**TO: PROSPECTIVE BIDDERS** **DECEMBER 10, 2021**

**RE: IFB-6711 – NEW CONSTRUCTION OF COMMUNITY SCHOOL 35**  
**ADDENDUM NO. 4 - CITY RESPONSE TO REQUESTS FOR INFORMATION AND CLARIFICATIONS**

## TYPICAL W10 (GRAVITY) COLUMN SPLICE DETAIL

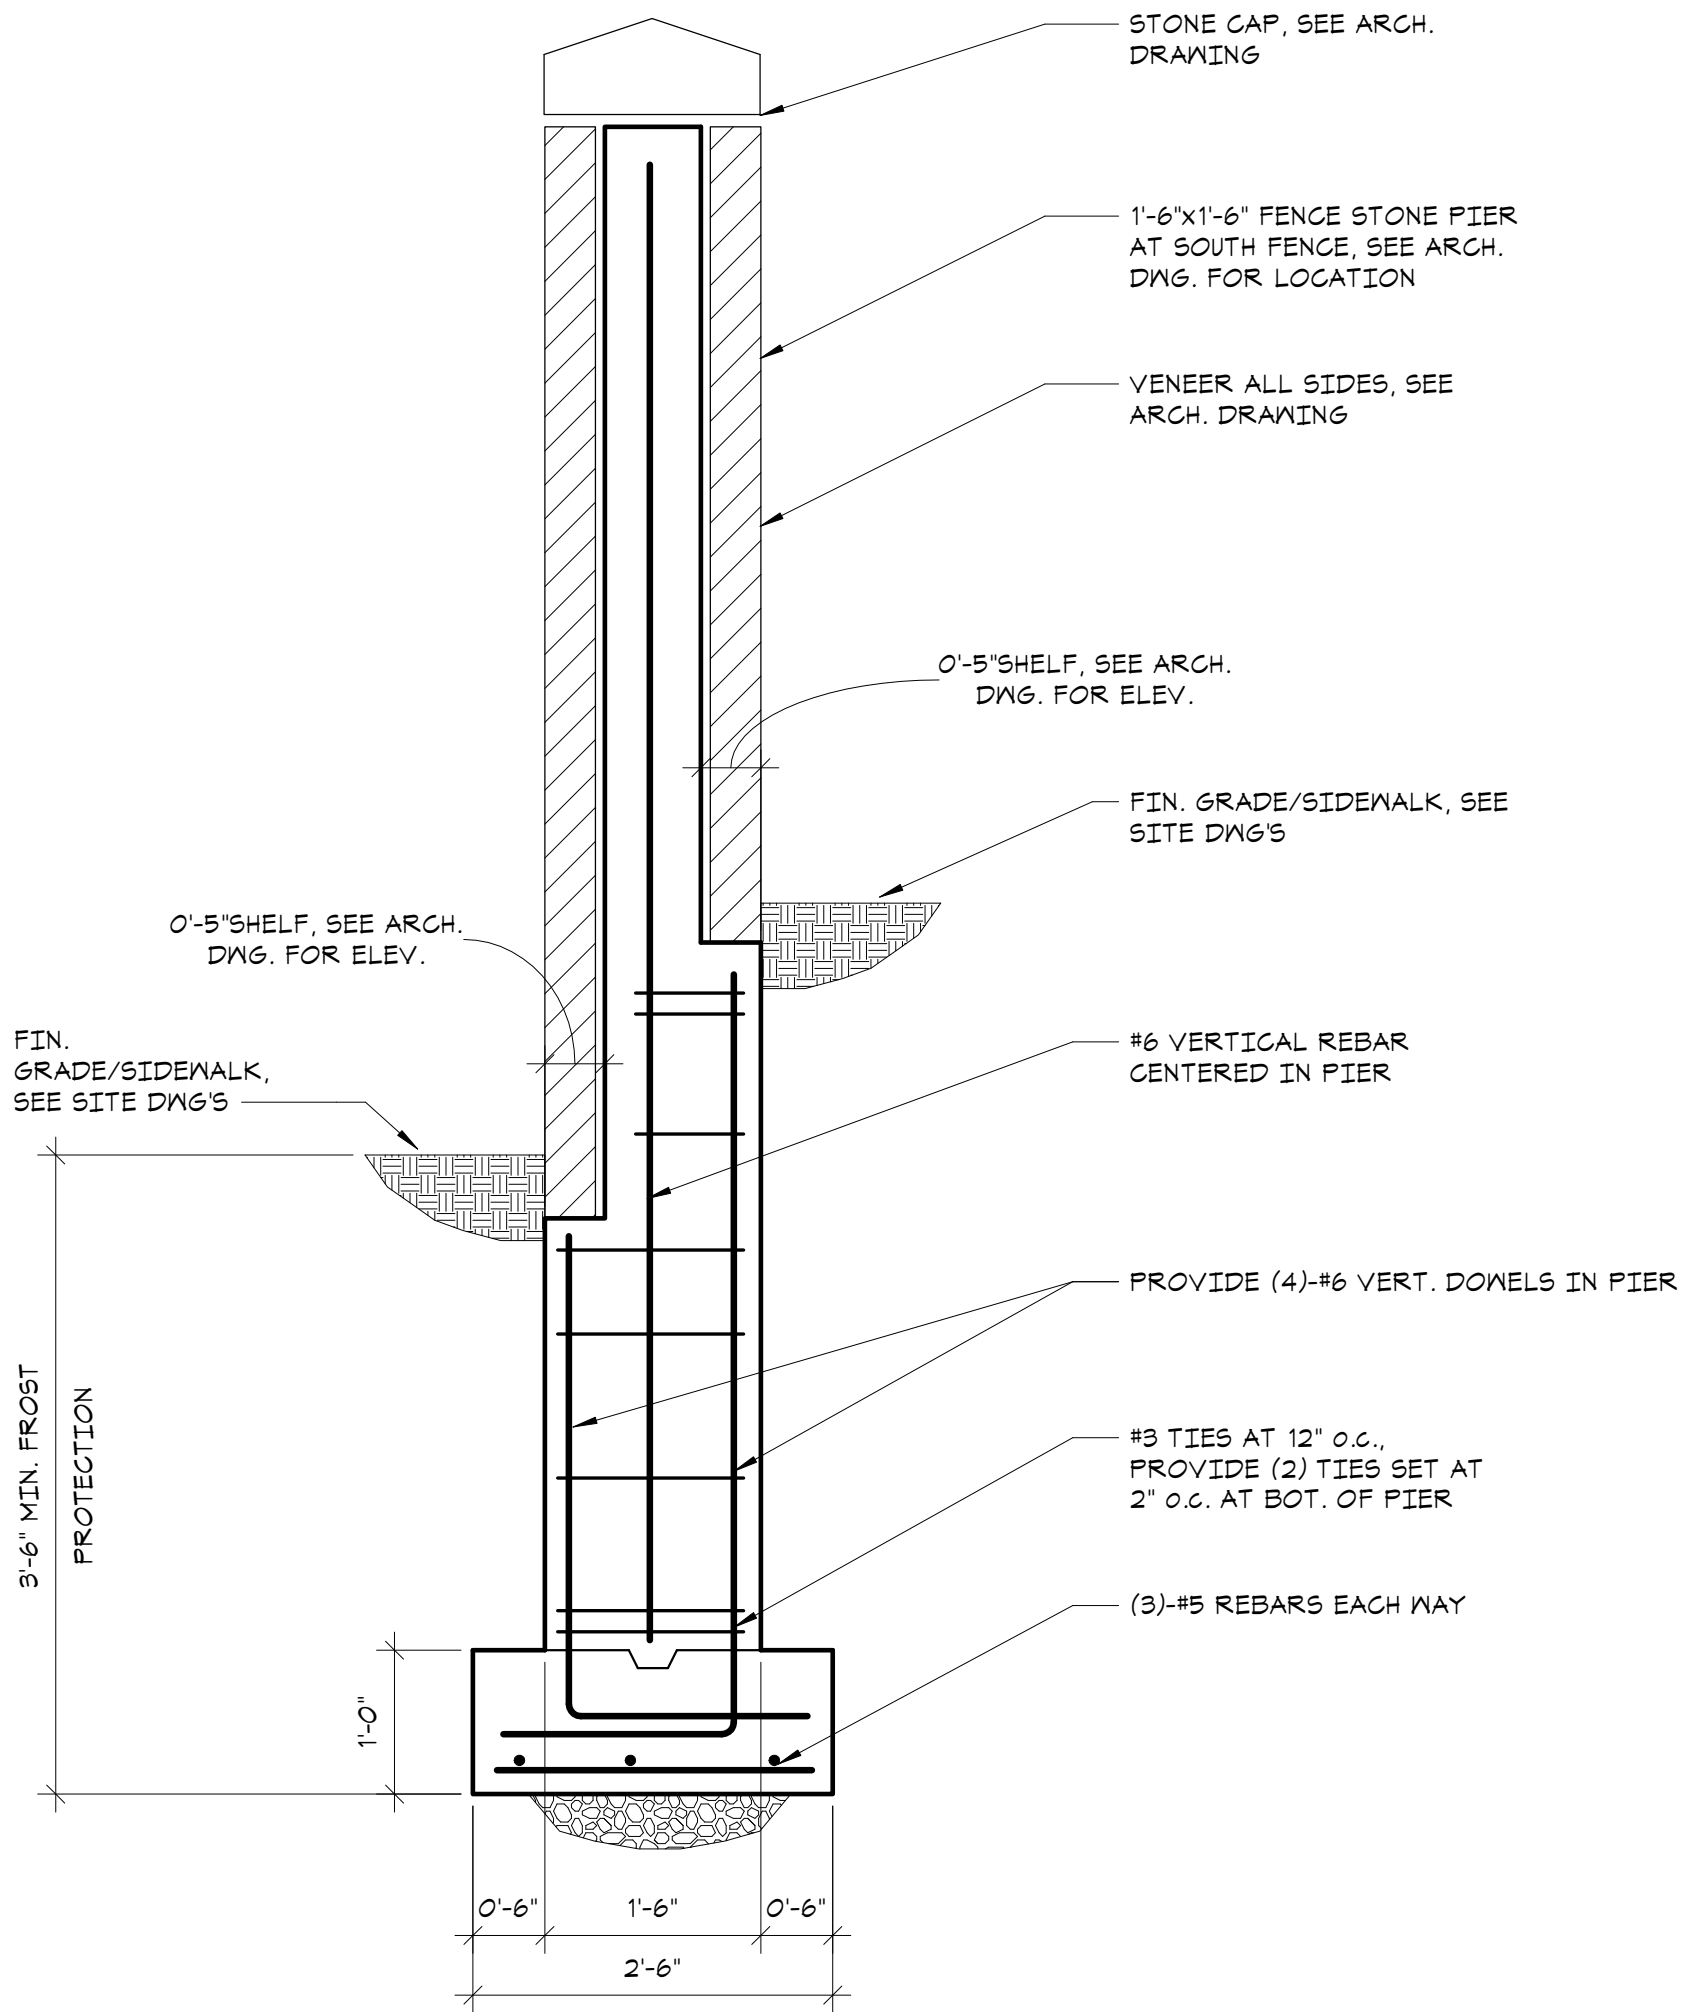
- 34. RFI:** Steel Column Schedule S302 and S303 does not show any column splices for columns that are continuous between the first floor and roof elevation. Please supply column splice details, and locations of required splices.

**YJSCB RESPONSE:** **See attached SSK-01 for column splice details.**
- 35. RFI:** There is a wall type 5 and 5A, I don't see it specified on A901 with the other wall types, can you please let us know what they are?

**NOTE:** FOR ALL W12 COLUMNS, ALL HSS COLUMNS AND ALL OTHER MOMENT FRAME (LATERAL) COLUMNS, PROVIDE GJP WELD AT SPLICE LOCATIONS

**1 H302 2ND FLOOR HVAC PIPING PLAN**

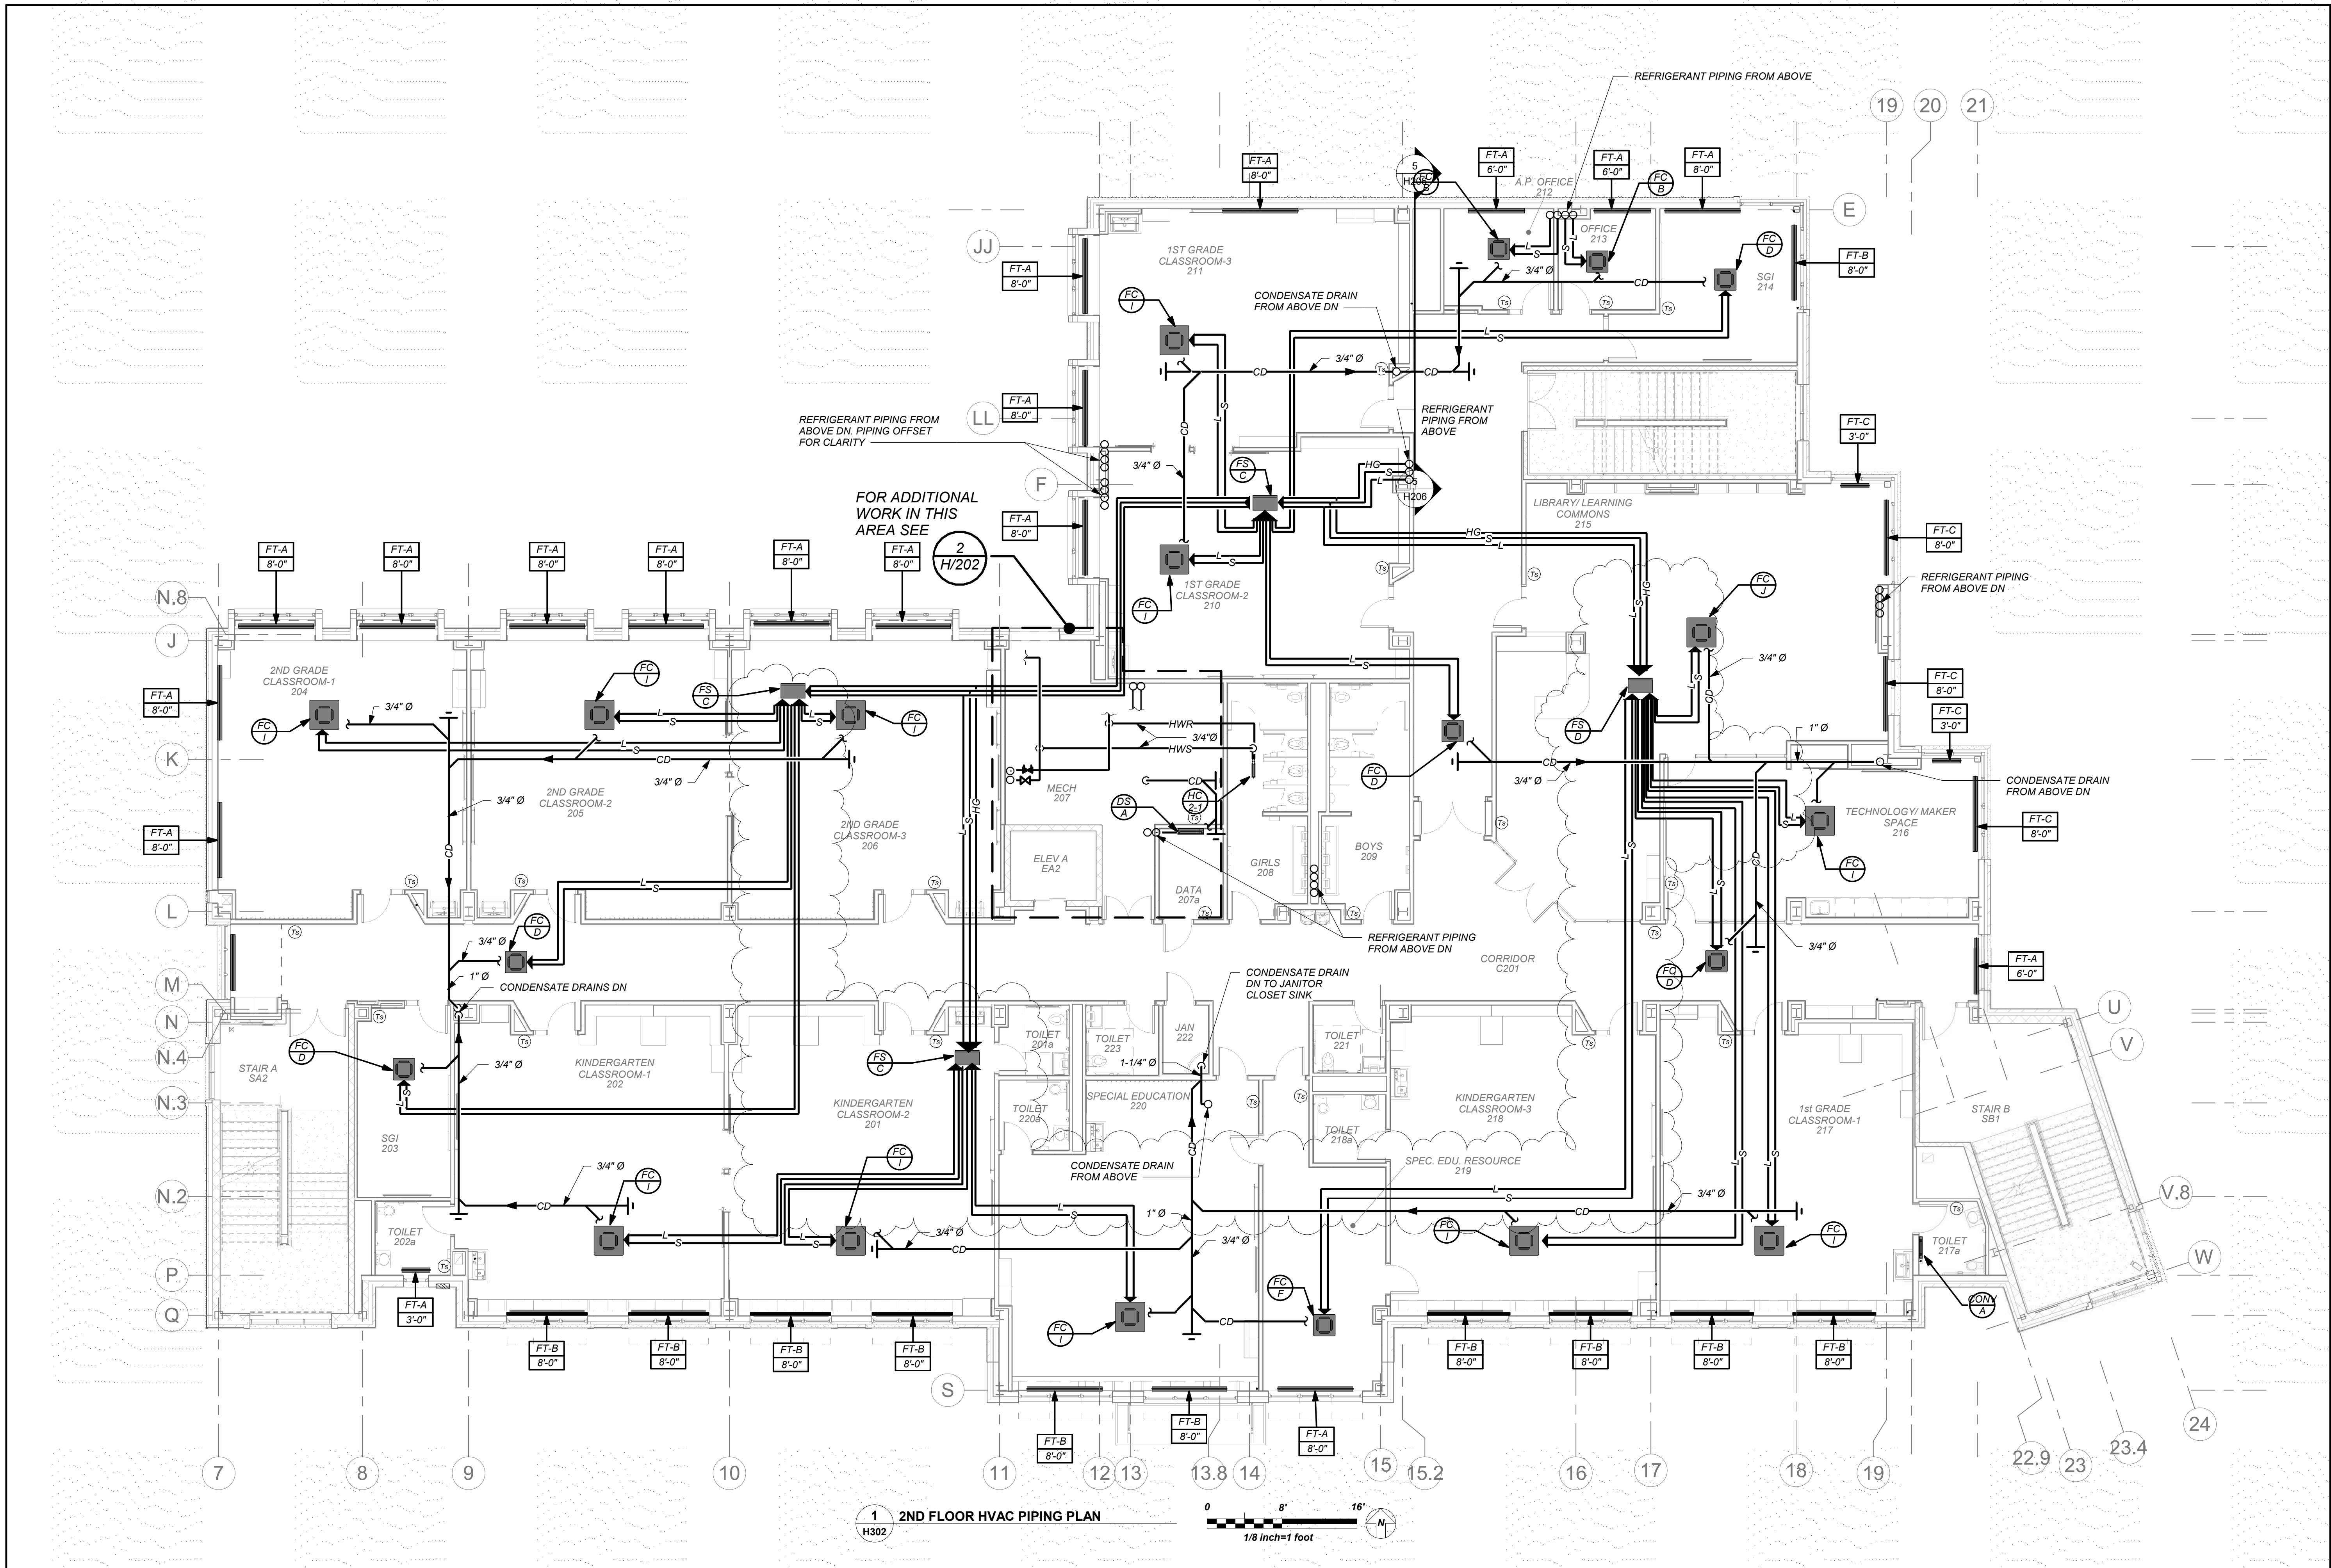
**8. DRAWING H302 – 2ND FLOOR PIPING**

1. 2ND Floor HVAC Piping Plan: Refrigerant piping revised. Refer to attached Drawing.
